RE: NOTICE OF VIOLATION NO. R9-2010-0015

FACILITY INSPECTION REPORT

FACILITY: Vulcan/Quarry Falls	WDID/401 File #: 937l005217	INSPECTION DATE/Time: 1/20/10; 1440					
FACILITY: Vulcan Materials Co., Mission Valley Operations							
REPRESENTATIVE(S) PRESENT DURING INSPECTION: Christina Arias (Regional Board)							
John Atkins, Plant Manager		619-778-6572					
NAME OF OWNER, PARTY RESPONSIBLE FOR DISCHAR	IGE OWN	ER CONTACT NAME AND PHONE #					
FACILITY OR DEVELOPER NAME (if different from owner)	FACII	LITY OR DEVELOPER CONTACT NAME AND PHONE #					
5745 Mission Center Road		San Diego, CA 92108					
FACILITY STREET ADDRESS	FACII	LITY CITY AND STATE					
APPLICABLE WATER QUALITY LICENSING REQUIREMENTS MS4 URBAN RUNOFF REQUIREMENTS NPDES NOS. CAS0108758, CAS0108740 or CAS0108766 GENERAL PERMIT ORDER NO. 99-08-DWQ, NPDES NO. CAS000002 - CONSTRUCTION GENERAL PERMIT ORDER NO. 99-06-DWQ, NPDES NO. CAS000003 - CALTRANS GENERAL OR INDIVIDUAL WASTE DISCHARGE REQUIREMENTS GENERAL OR INDIVIDUAL WAIVER OF WASTE DISCHARGE REQUIREMENTS SECTION 401 WATER QUALITY CERTIFICATION CWC SECTION 13264

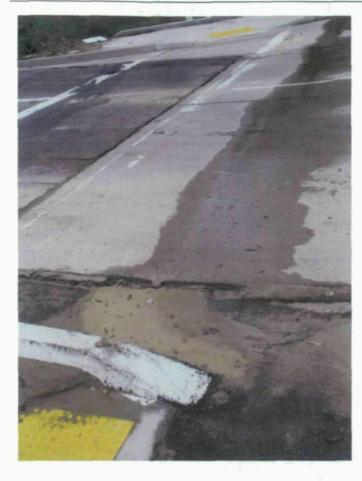
Sediment flow has overwhelmed silt fence and fiber rolls and made its way to conveyance (MS4).

Some sediment has been captured by curb, but is nearing height of the curb.

- More silt fences/sand bags are needed to capture moving sediment. Slopes should be re-sprayed heavily with BFM or equivalent erosion control implemented ASAP.
- An email was sent to John Atkins, Plant Manager, regarding urgent need to deploy more BMPs (attached).
- Photos were sent to the City of San Diego's storm water hotline on 1/25/10. A code compliance officer visited the site
 on 1/26/10 to ensure BMPs were improved.
